**Re: PART 573 NOTICE RE ARVINMERITOR ADAPTER PLATE BOLT TORQUE**  
**(10E-014)**

Safety Defect and Noncompliance Report Guide for Vehicles  
**PART 573 Defect and Noncompliance Report**

### Inspect for Under-Tightened Hub/Rotor/Adapter Plate Bolts on Meritor Front Non-Drive Steer Axles and Tag Axles Equipped with Unitized Wheel Ends Installed on Motor Coach Industries (MCI) Coaches

### Check Hub/Rotor/Adapter Plate Bolt Torque on the Unitized Wheel Ends

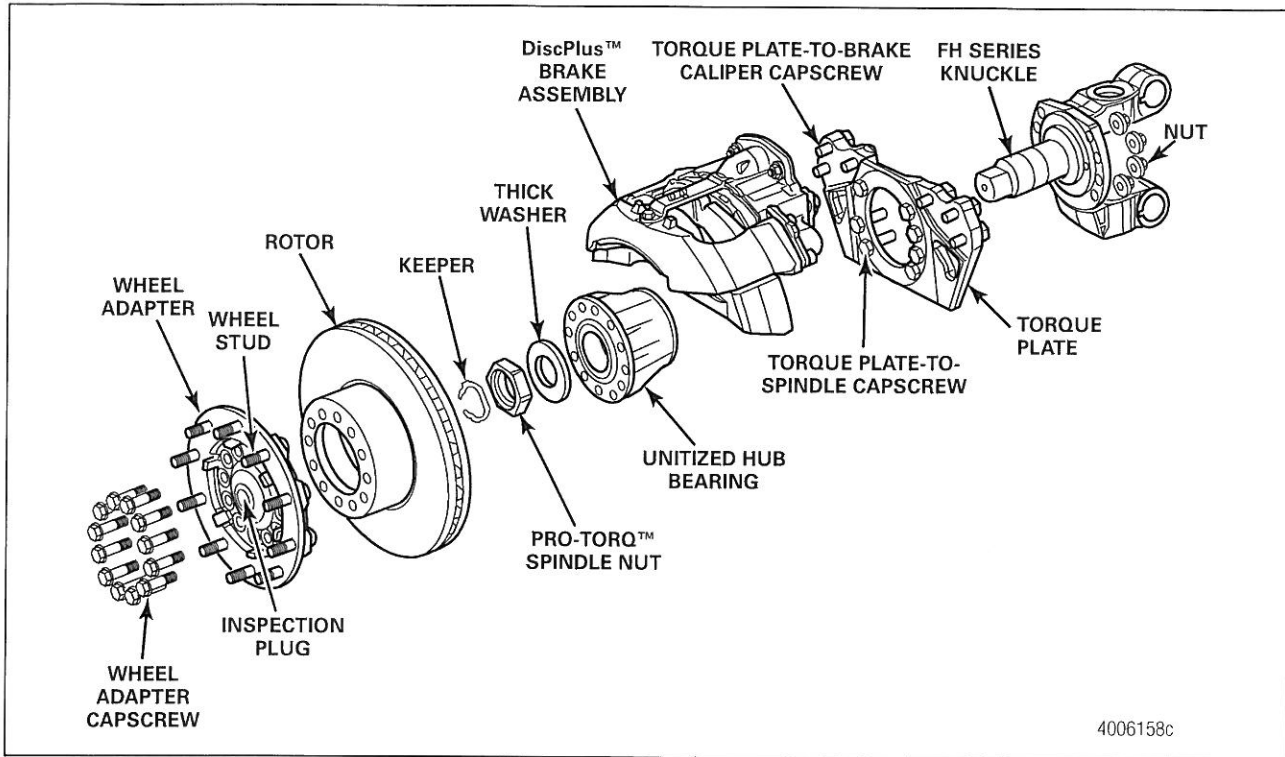
3. Use a torque wrench with a dial indicator to check hub/rotor/adapter plate bolt torque on all 12 bolts on each unitized wheel end. The bolt torque must not be less than 150 lb-ft (203 N•m). Record the torque on the Inspection Sheet included in this bulletin. 
  - If hub/rotor/adapter plate bolt torque on any one of the 12 bolts on each unitized wheel end is less than 150 lb-ft (203 N•m): Replace the bolt using ArvinMeritor part number 10X1711. Discard the bolts that were removed. Do not reuse old bolts. Record the bolt replacement on the Inspection Sheet included in this bulletin.

- If any two or more bolts in the same bolt circle on a wheel end are less than 150 lb-ft (203 N•m): Replace all 12 bolts on the untized wheel end using ArvinMeritor part number 10X1711. Remove, replace and tighten each bolt one at a time to maintain the correct clamp load on the wheel end. Discard the bolts that were removed. Do not reuse old bolts. Record the bolt replacement and torque in the Inspection Sheet included in this bulletin.

4. Use a click torque wrench to tighten all remaining bolts and any replacement bolts in a star pattern to  $275 \pm 25$  lb-ft ( $373 \pm 34$  N•m). Record the torque on the Inspection Sheet included in this bulletin. When you have tightened all of the bolts, recheck the torque of all 12 bolts in a star pattern. **ⓘ**
5. Mark a stripe on all of the tightened bolts. Use a different color than the color already used.
